ADDENDUM NO. 1

Date of Addendum: 2/1/16

PROJECT NAME: New / Replacement of Water Well – Forest Cove III

PROJECT NO: WBS No. S-000100-0016-4

WBS NUMBER	FOR CITY OF HOUSTON USE ONLY
S-000100-0016-4	
DRAWING SCALE	
VERT. 1"=2' HORIZ. 1"=20'	
CITY OF HOUSTON PM	
NA YAO, P.E.	
SHEET NO. 7 OF 26

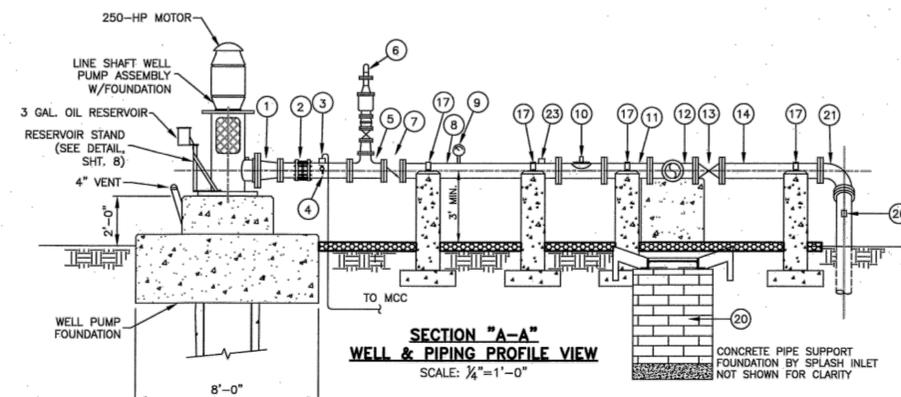
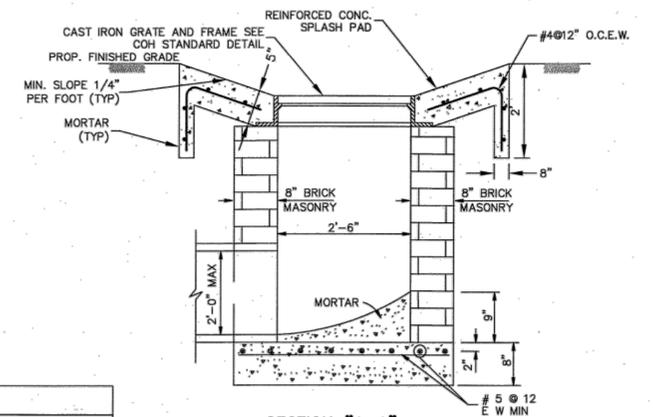
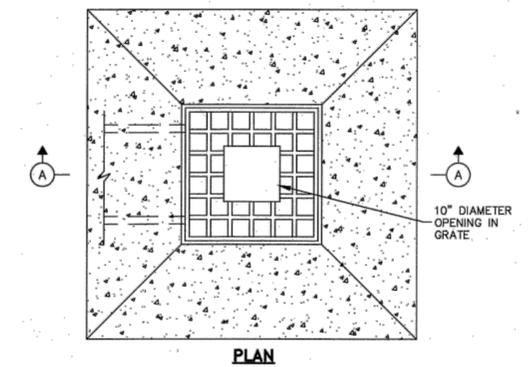
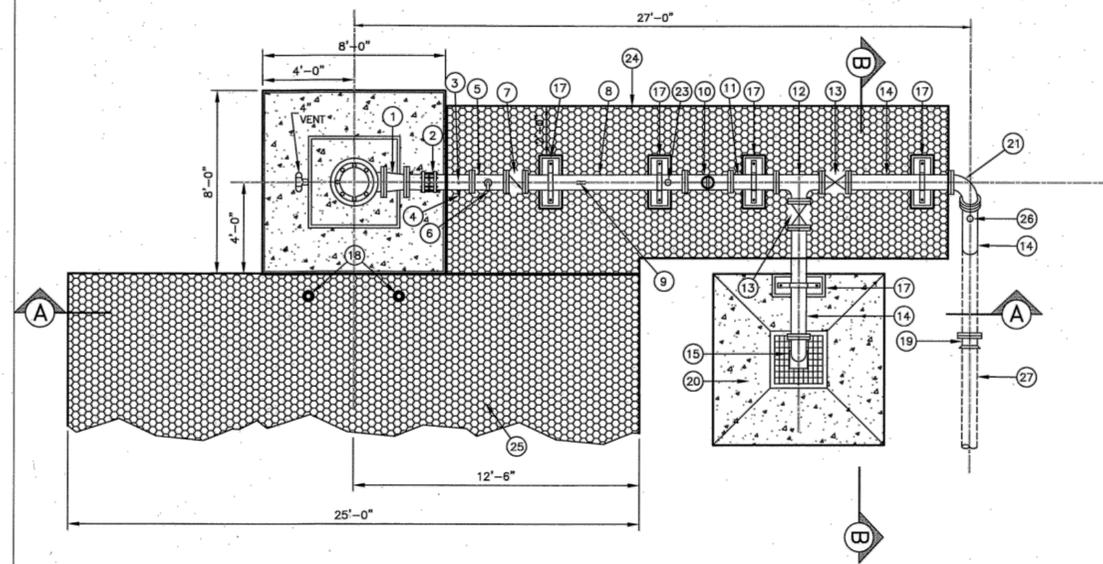
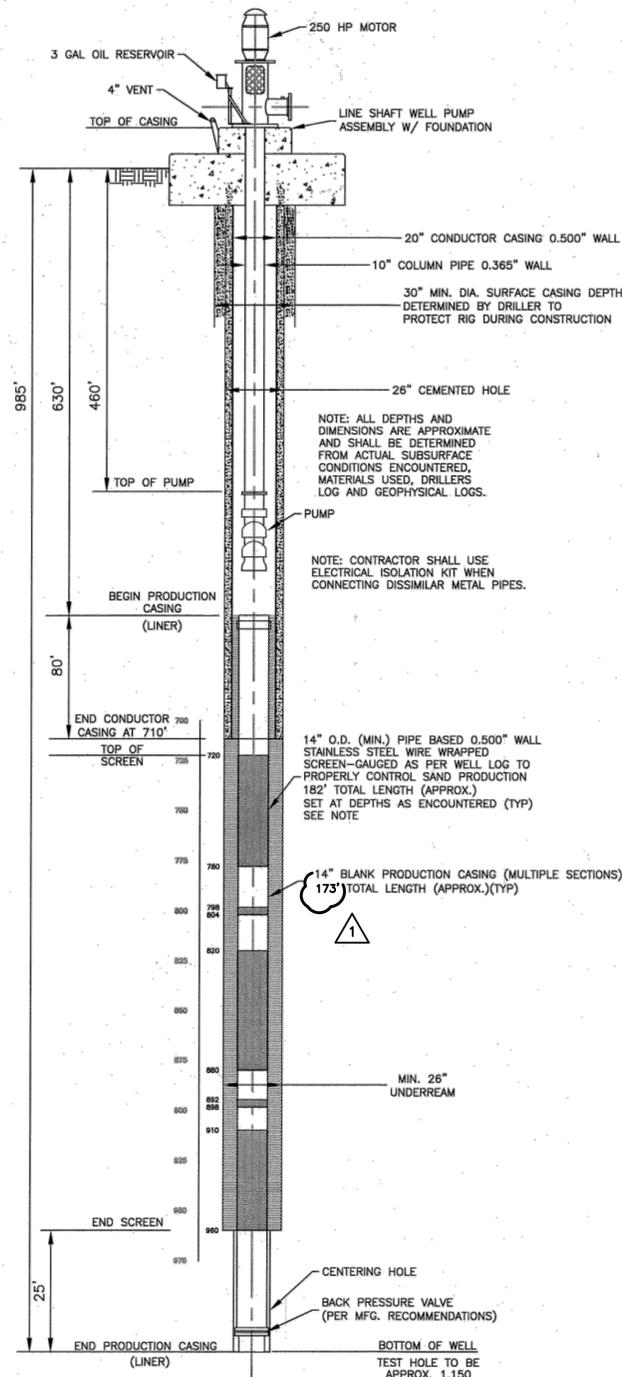
25. Question: Plan Sheet No. 7 and Bid Item No. 21 call for 253 feet of 14-inch diameter steel blank production casing. The Well Dimensions Schedule in Spec. Section 02529 calls for 173 feet of blank production casing. Bid Item No. 21 should reference 173 feet of blank production casing and 182 feet of screen. Will you correct Bid Item No. 21?

- Answer: The blank production length of 173 feet listed in Section 02529 is correct. Plan Sheet No. 7 and Bid Item No. 21 are revised.
26. Question: Bid Item No. 2.1. includes a sound barrier. Can you provide any information regarding this sound barrier? For example, is this a temporary sound barrier or something permanent? Are there any dimensions required (height, length, etc.)? Are there any required structural materials or engineering designs? Are there any noise reduction requirements?

STORM SEWER PLAN & PROFILE	
WBS NUMBER	FOR CITY OF HOUSTON USE ONLY
S-000100-0016-4	
DRAWING SCALE	
VERT. 1"=2' HORIZ. 1"=20'	
CITY OF HOUSTON PM	
NA YAO, P.E.	
SHEET NO. 12 OF 33

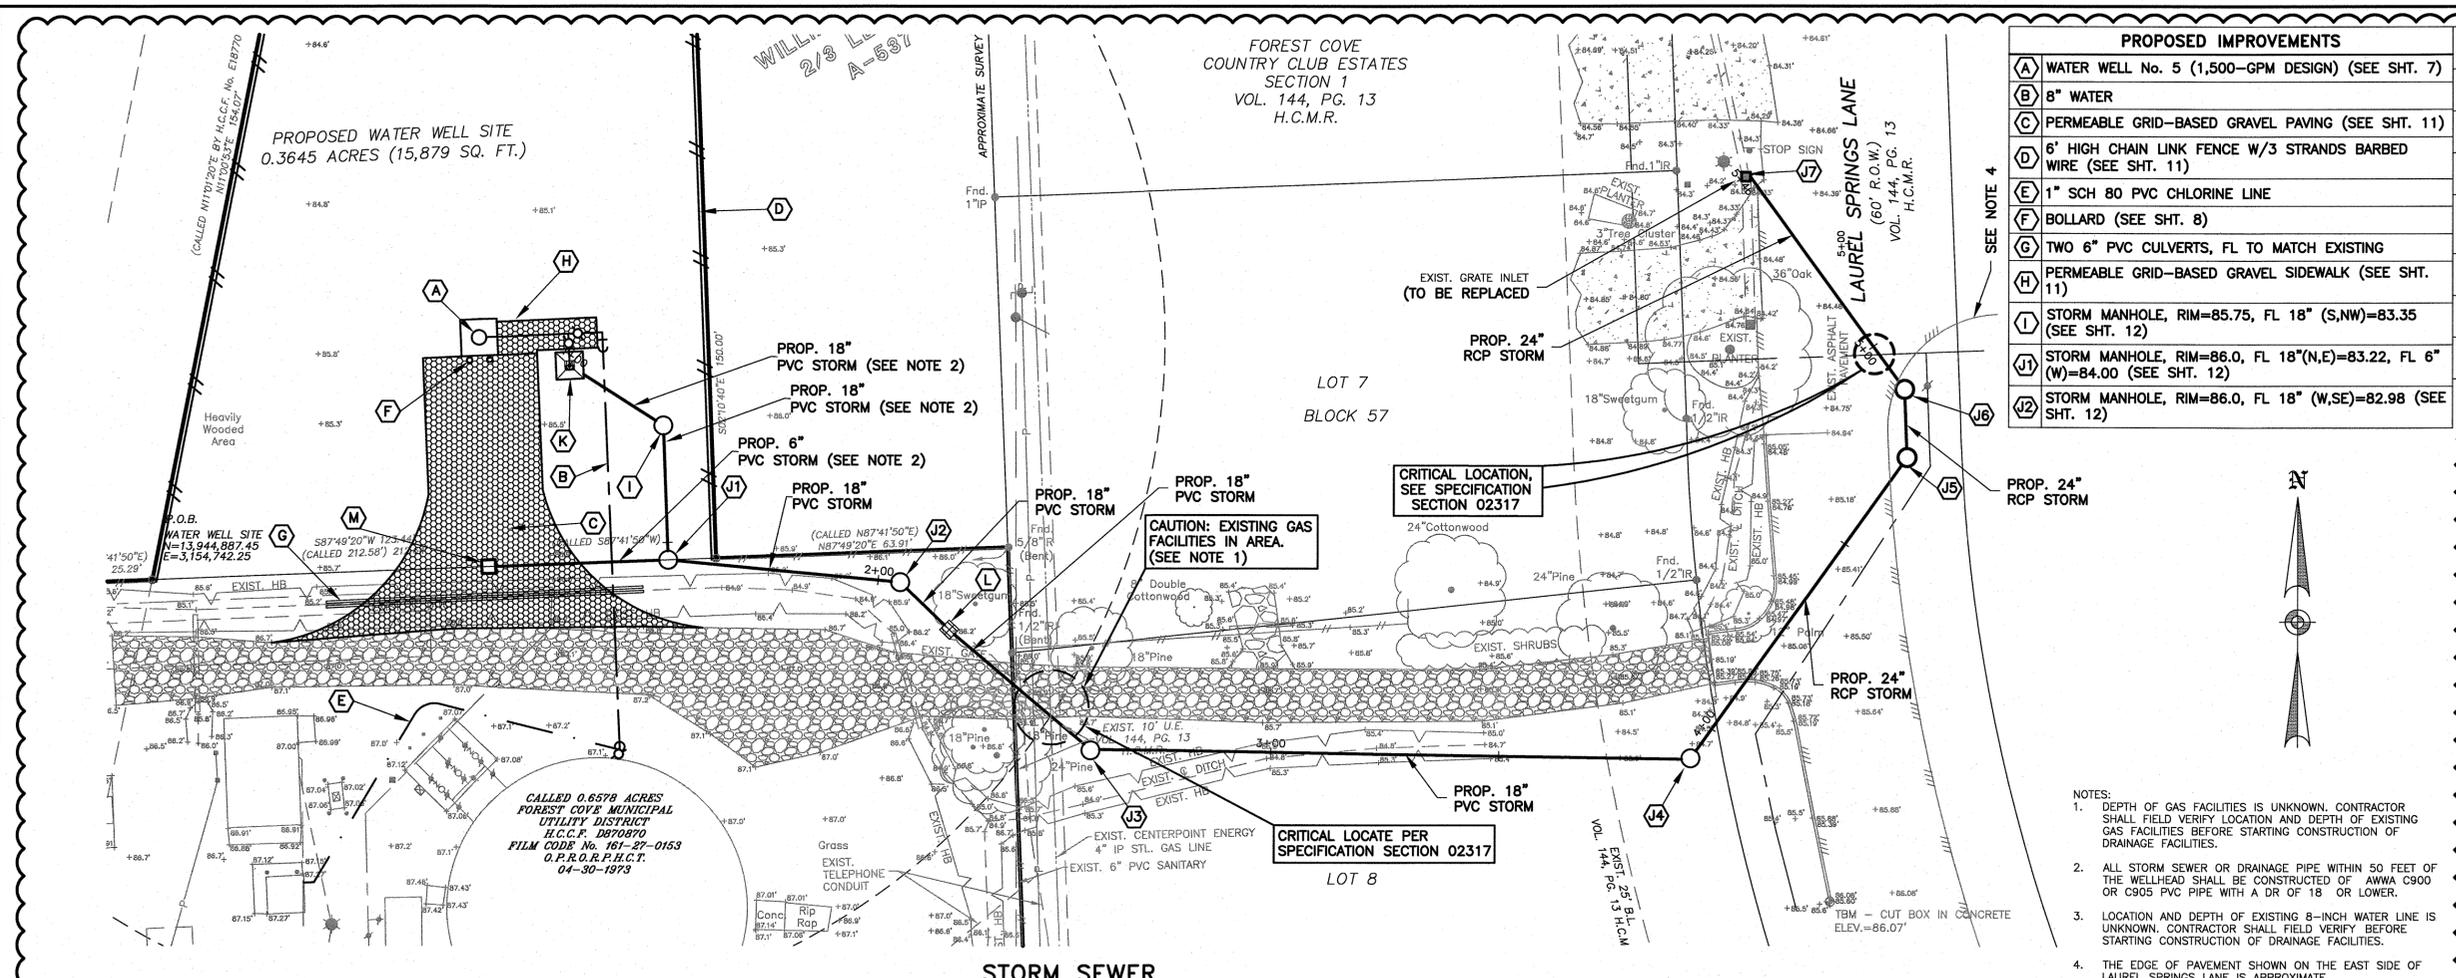
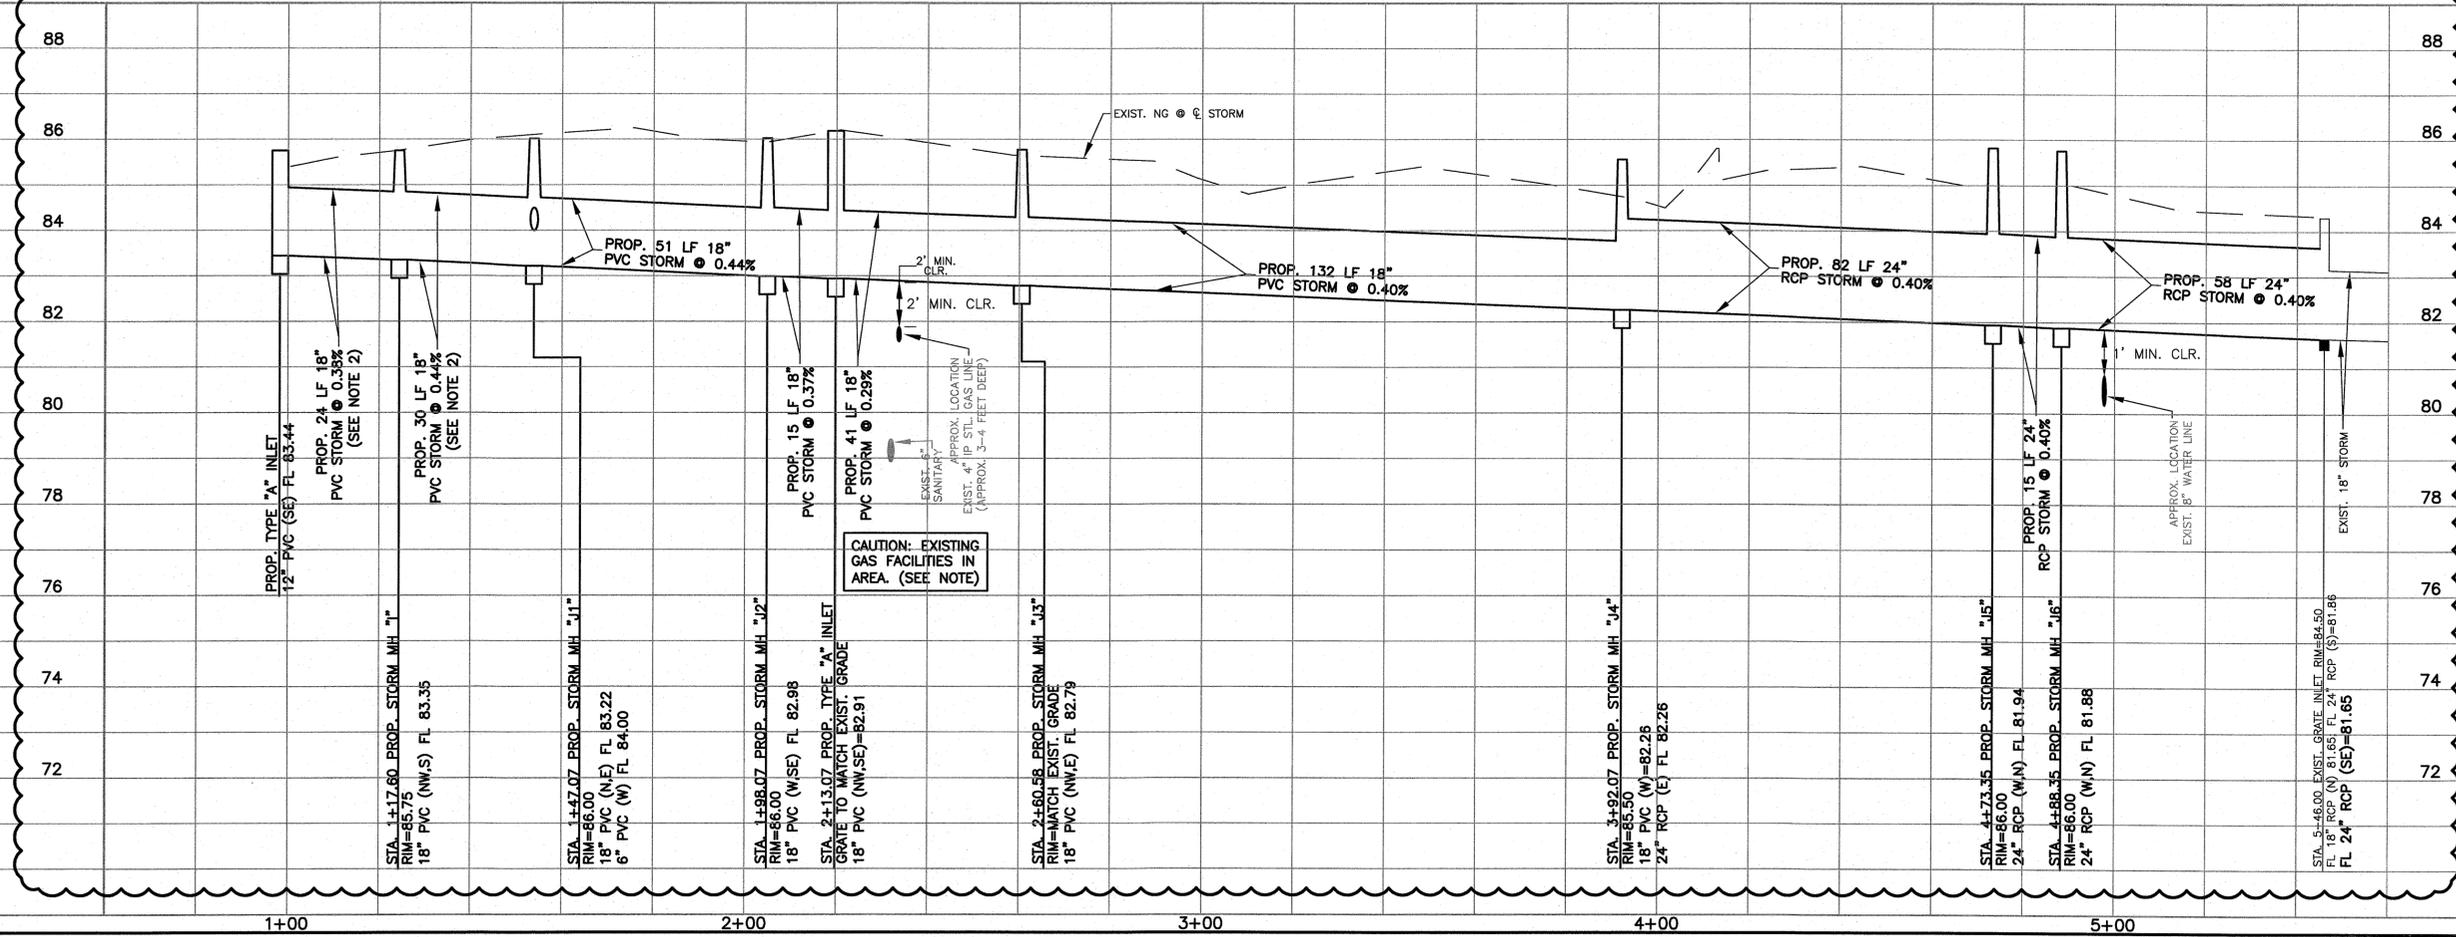
21. Question: What should be done about the tree listed as a 36-inch oak at the end of the proposed storm sewer line, by inlet 21?
- Answer: The storm sewer line's route from the water well site has been revised to protect the tree. The new route includes borings under Laurel Springs Lane.
